Access Compliance Report Public Rights-of-Way (Curb Ramps)

Main Street: AIROSO_ST Cross Street: ANDAZA_ST Location: W

ADA ID: RPRK211203115225 Ramp Type: Type 1 - Perpendicular Initial Pass/Fail: Fail Overall Compliance: No Severity Score: 16

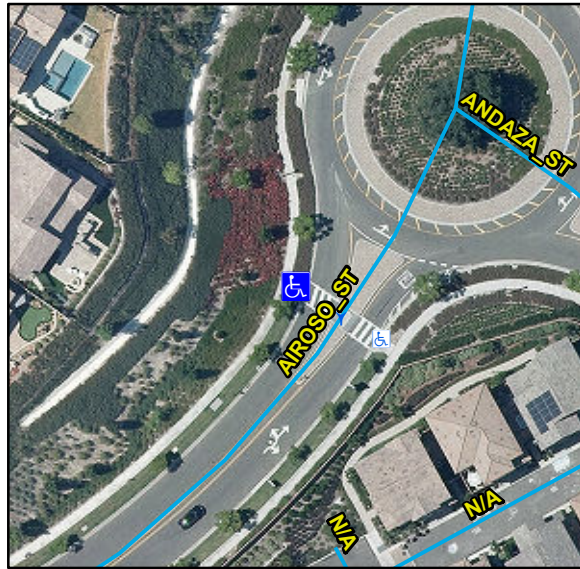
R304.2.2, R304.5.3, STD 1115

Remove & Replace Entire Ramp.
